Technical Service Bulletin:

Overload Relay – Set Point Adjustment

Models: SV/LV036-1, SV/LV/QV036-2, & SV/LV042-1 (PSC Only)

Figure 1

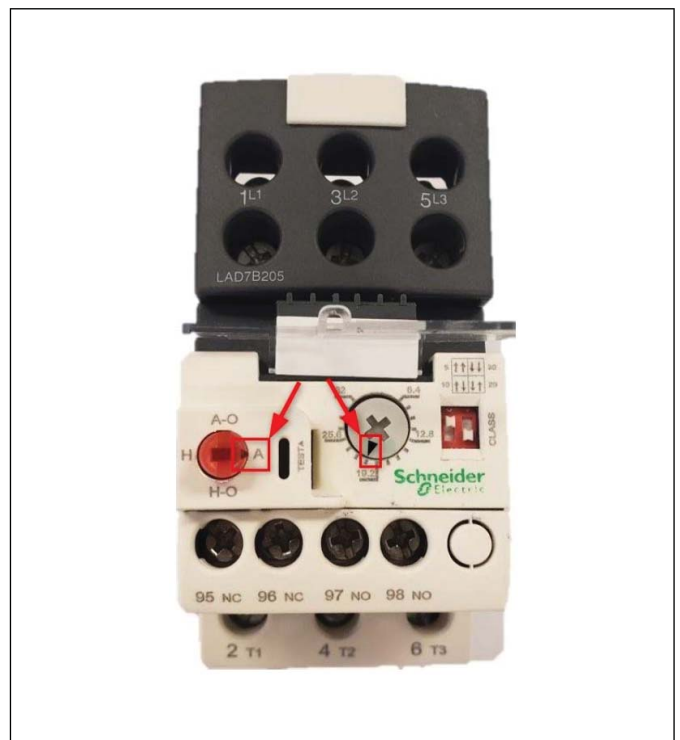
Some models of LV, SV, and QV heat pumps, under the specific conditions shown below, may experience the overload relay to trip and require a manual reset:

- ▶ Unit is in “manual” mode.
- ▶ The water entering the system is higher than 105°F.
- ▶ Unit starting up with no water flow.
- ▶ SV/LV/QV036 units with water entering the system with a flow rate that is lower than 4.5gpm.
- ▶ SV/LV042 units with water entering the system with a flow rate that is lower than 5.1gpm.

1. Turn the power off to the heat pump.
2. Refer to Figure 1, and set the two dials as follows:
 - a. Rotate from “H” to point to “A”.
 - b. Move current set point to “20.8” position.
